Docket Item # 3
BAR CASE # 2008-0107

BAR Meeting
July 23, 2008

ISSUE: Addition/alterations
APPLICANT: Ralph Timmons
LOCATION: 309 North West Street
ZONE: RB/Residential

Figure 1: Existing conditions at 309 North West Street (top two) and example of proposed deck (bottom).

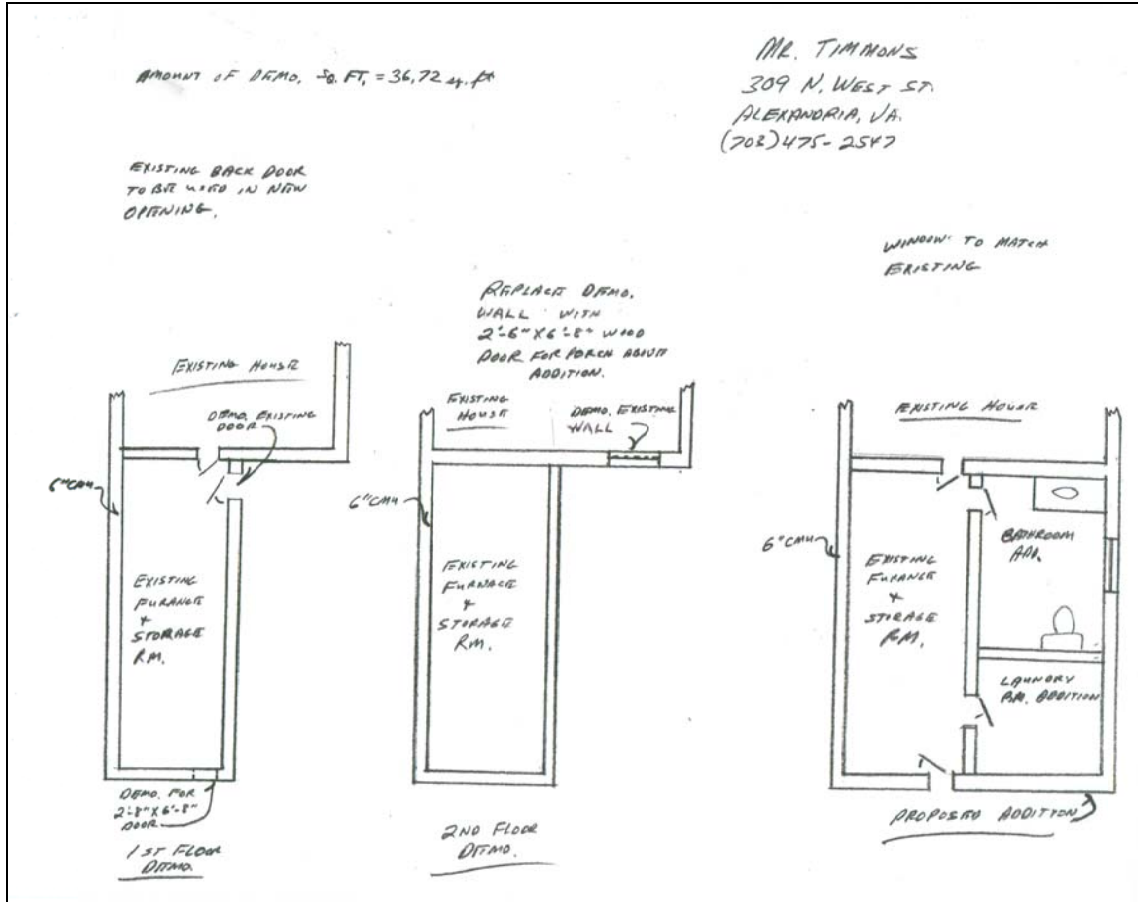
Rear of 309 N. West
Serv Rm will be
expanded across
the back. Doors cut
center 1st & 2nd floor.
Deck built over
Serv Rm.

Door will move to
back center.
Motion detector
lights similar to
picture to be
installed in upper
right of doors on
1st and 2nd floors.

Rear of 313 N
West is a deck
similar to this
proposal.
